# Aqua Lung America **TECHNICAL BULLETIN**

Jan 31, 2010  
No. 30

**SUBJECT: POWERLINE GRAY BUTTON COVER (PN 15100)**

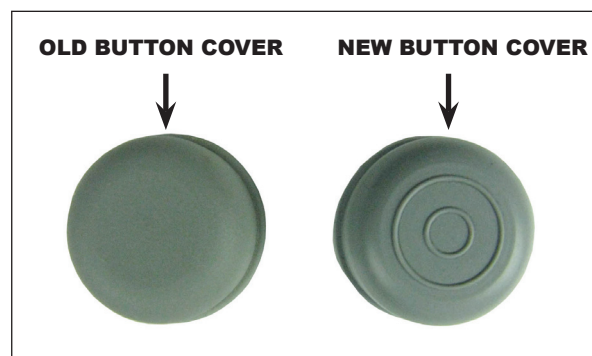
Aqua Lung is aware that some of the **Gray** Powerline Inflator buttons are not as durable as we had anticipated. Some buttons show aging, discoloration and lack of resiliency (they remain compressed).

To improve this situation, Aqua Lung has made a material change to the button which will provide better performance and longevity. The image below helps you to identify an older button from the improved button.

In an effort to upgrade the buttons in the field, Aqua Lung will be including the improved button in each of the Powerline service kits, p/n 42609, at no additional charge, for a period of one year. When servicing a Powerline inflator, please take the time to swap out an older button for an improved one.
